### Manfield Preliminary Plan No. 120160360

Staff Report Date: July 10, 2017

- Request to subdivide one recorded lot into two one-family residential lots
- 5115 Bradley Boulevard
- Size: 28,592 square feet (0.66 acre)
- Zone: R-60
- Master Plan: 1990 *Bethesda-Chevy Chase*
- Applicant: Melanie Manfield
- Date Accepted: August 10, 2016
- Review Authority: Chapter 50, effective February 13, 2017

Figure 3: Proposed Preliminary Plan

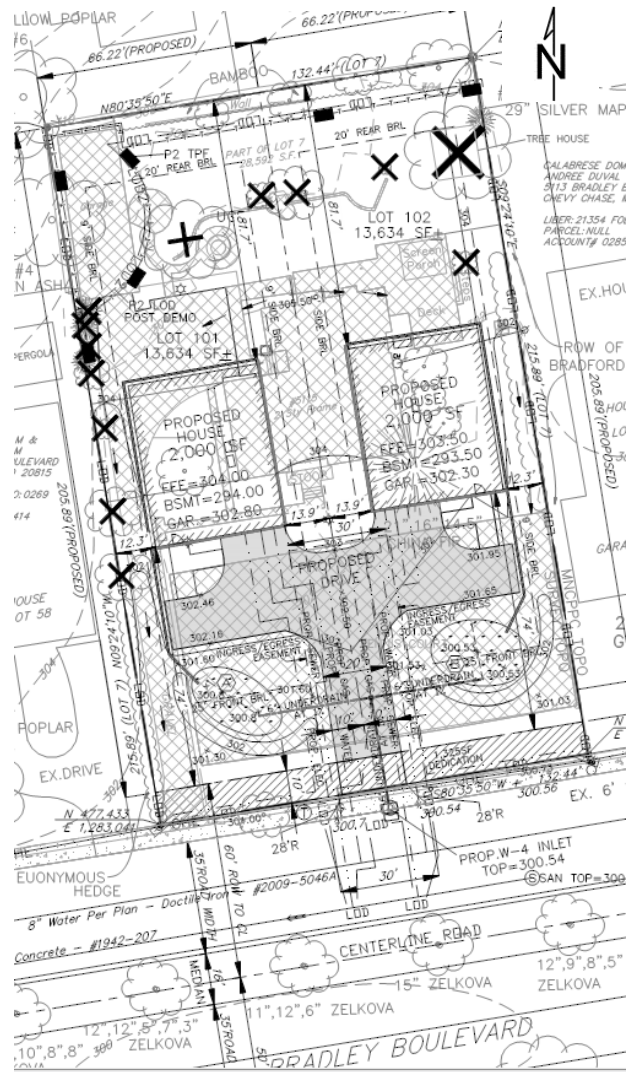
As shown on the submitted Preliminary Plan, the Project will dedicate a 10-foot wide strip across the site's entire frontage for a total of 1,325 square feet. This dedication will provide the minimum width of 60 feet between the property line and the MD 191 right-of-way centerline. This dedication supports the Master Plan recommendation for a right-of-way width of 120-feet on MD 191 and is a recommended condition of approval.

The Project proposes eliminating the site's existing driveway from MD 191 in favor of a single right-in/ right-out shared driveway located in the middle of the site's frontage on MD 191, approximately 53 feet east of the existing driveway. The proposed access concept is preferable to the existing condition because it consolidates access to a single point between the two proposed lots.

Currently, the proposed driveway location is improved with a storm drain inlet that must be relocated outside of the proposed driveway apron to facilitate safe and adequate vehicular ingress/ egress. MSHA may permit the driveway to be constructed around the existing inlet or in the alternative require the Applicant to relocate the inlet along the site's frontage. Staff recommends a condition of approval to address the storm drain inlet.

7. The record plat must show a common access easement from Bradley Boulevard (MD 191) over the shared driveway.
8. Prior to recordation of plat, the Applicant must satisfy the provisions for access and improvements as required by Maryland State Highway Administration (MSHA) including relocating the existing storm drain inlet outside the limits of the proposed driveway apron, unless this requirement is waived by MSHA.

9. The Applicant must dedicate 10-feet along the Subject Property’s frontage as mandated by the 1990 *Bethesda-Chevy Chase Master Plan* and as shown on the Preliminary Plan.
